## DOCUMENT CHANGE REQUEST

DCR number 251 Changes required for: General

Title: Transistors Low Power NPN, based on type 2N2222A

Number: 5201/002

### 1.6.1 Metal Can Package (TO-18) - 3 lead

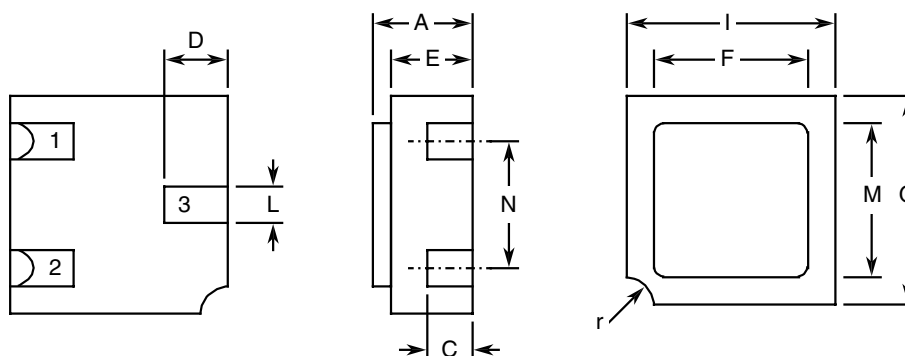
6. Para. 4.3.2 Weight Requirements moved to Component Type Variants table.
7. Figure 2 re-named .Physical Dimensions and Terminal Identification.; Figure 2(a) amended to reflect the TO-18 package currently supplied. Notes revised, including addition of a terminal identification note.

8. Para. 4.4.1 Case Requirements for Variants 01, 02, 06 and 07 corrected to reflect a TO-18 metal can.
9. Para. 4.4.2 Lead Material and Finish replaced by a reference to the Component Type Variants Para.

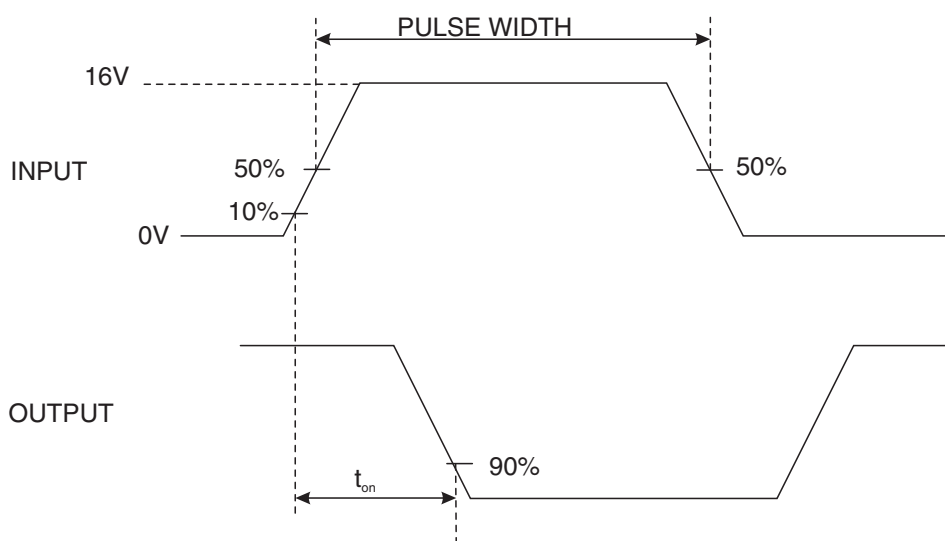
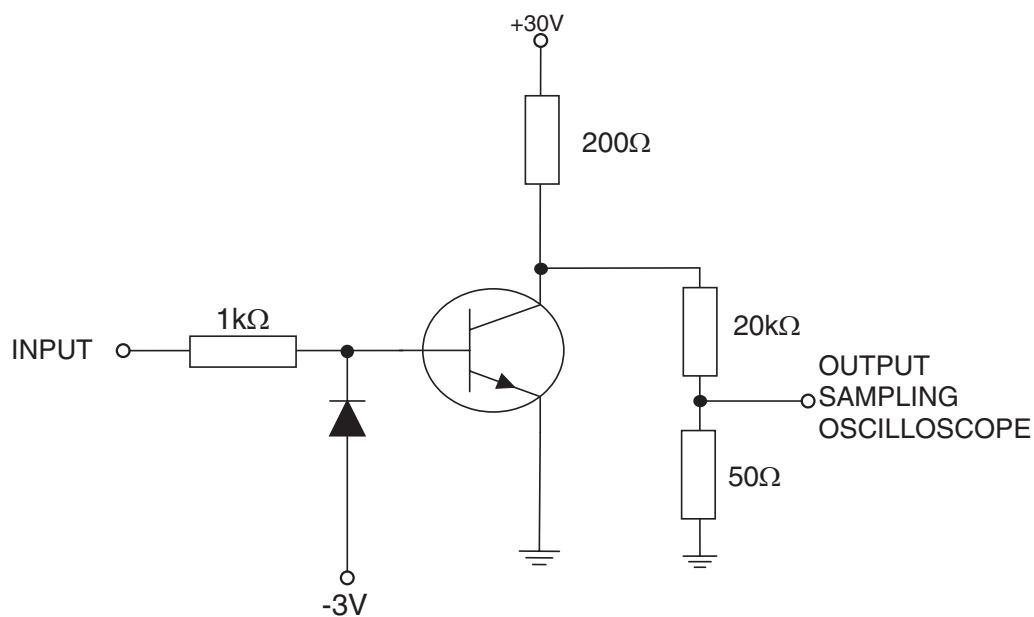
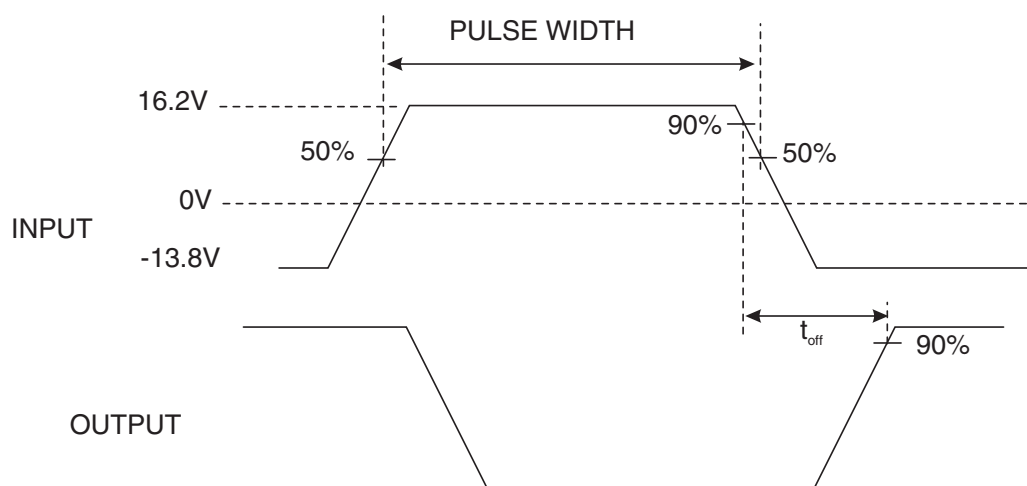
16. Table 2 and Figure 4: Turn-on Time and Turn-off Time have been amended to reflect the new format.
17. Table 3 (High and Low Temperature Electrical Measurements): 100% inspection has been replaced by a sample of 5 components with 0 failures, or 100%, in line with the new Generic 5000 Issue 3.
